CITY PLANNING COMMISSION

- APPLICATION:
1. Environmental Determination
 2. Plan Review for 26 apartment units on 1± acres in the R-3-R zone
 3. Lot Line Adjustment to merge two parcels (Subdivision Ord. Sec. 40.107)

LOCATION: Northeast corner of Northview and Northfield Drives

PARR APARTMENTS

EXHIBIT A

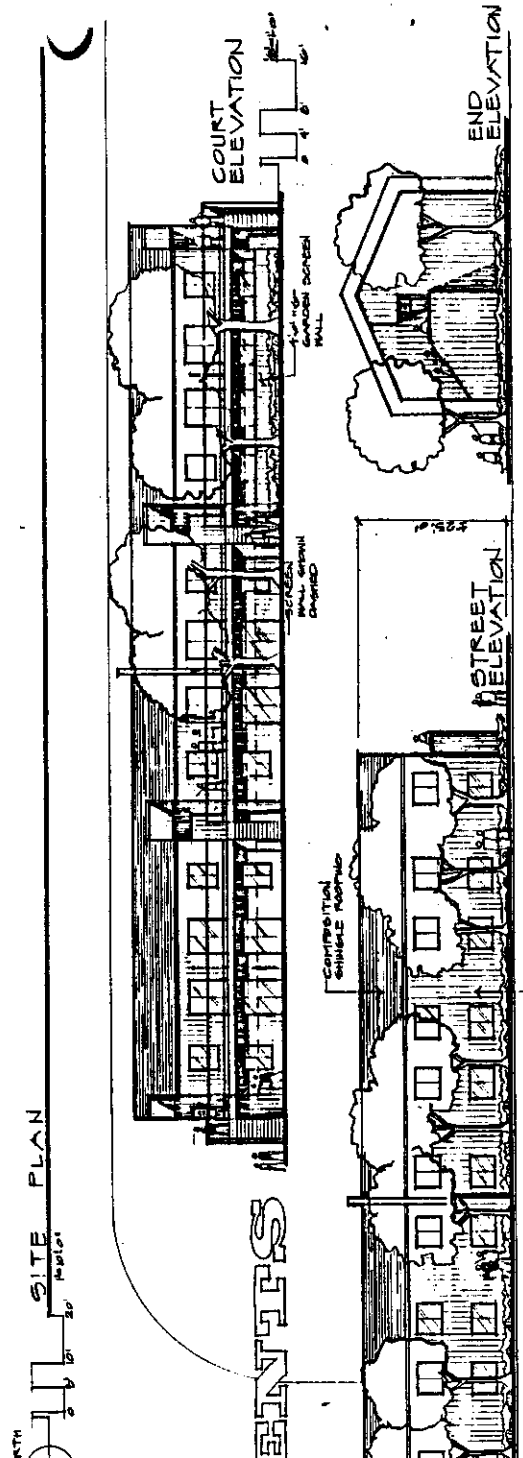
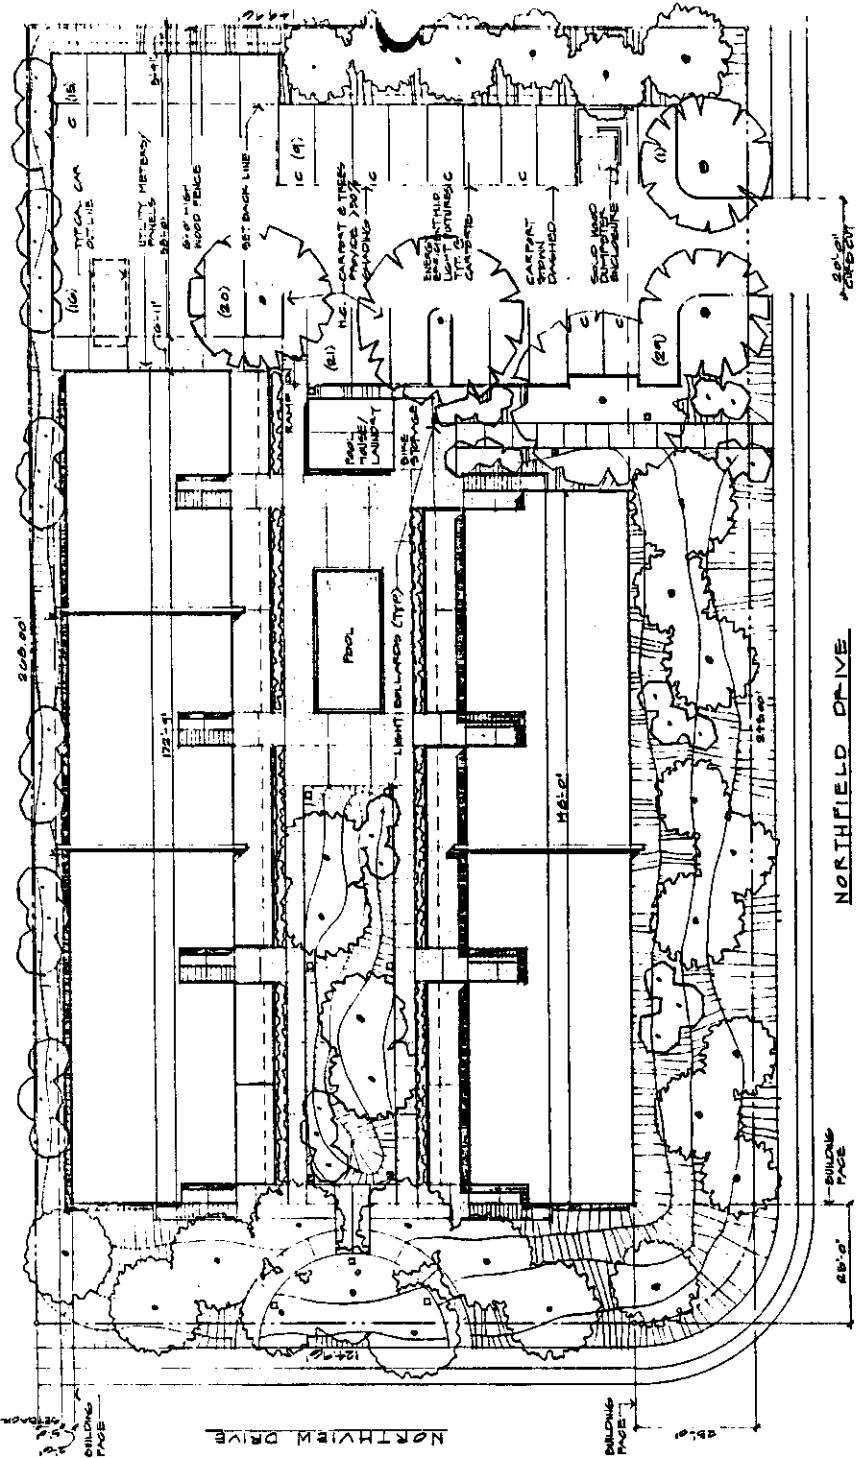
1. The original project (Exhibit A) consisted of two rectangular structures, two-stories in height constructed of T-111 plywood siding and composition shingle roof.

The staff, as well as the South Natomas Advisory Committee, had serious concerns regarding the design, configuration of the buildings and overall site layout.

- a. The south facing elevation of the building abutting Northfield Drive shall be redesigned to incorporate three stepped back sections with each offset set setback a minimum of two and one-half feet;

- b. The north building shall be moved back two and one-half feet to the north to the minimum five foot side yard setback to retain the interior courtyard space as approximately the same size as originally proposed;

- c. The south elevation of the south building shall have alternating dipped and overhung eaves, fin walls and wood sun trellis;
- d. The north building shall have continuous 30-inch eave overhang at the north and south elevations;

- e. Horizontal hardboard siding shall be used in lieu of T-111 siding as originally proposed;
- f. Thirty percent of the on-site parking spaces shall be compact car spaces;

- g. Pedestrian access from the court area to Northview Drive shall be eliminated. A three-foot high decorative open metal (wrought iron) type fence without gate shall be installed between structures to discourage tenant parking on street;

- 1) The south facing elevation of the building abutting Northfield Drive shall be redesigned to incorporate three stepped back sections with each offset setback a minimum of two and one-half feet;

- 2) The north building shall be moved back two and one-half feet to the north to the minimum five feet side yard setback to retain the interior courtyard space as approximately the same size as originally proposed;

- 3) The south elevation of the south building shall have alternating dipped and overhung eaves, fin walls and wood sun trellis;
 - 4) The north building shall have continuous 30-inch eave overhang at the north and south elevations;

- 5) Horizontal hardboard siding shall be used in lieu of T-111 siding as originally proposed;
 - 6) Thirty percent of the on-site parking spaces shall be compact car spaces;

- 7) Pedestrian access from the court area to Northview Drive shall be eliminated. A three-foot high decorative open metal (wrought iron) type fence without gate shall be installed between structures to discourage tenant parking on street.
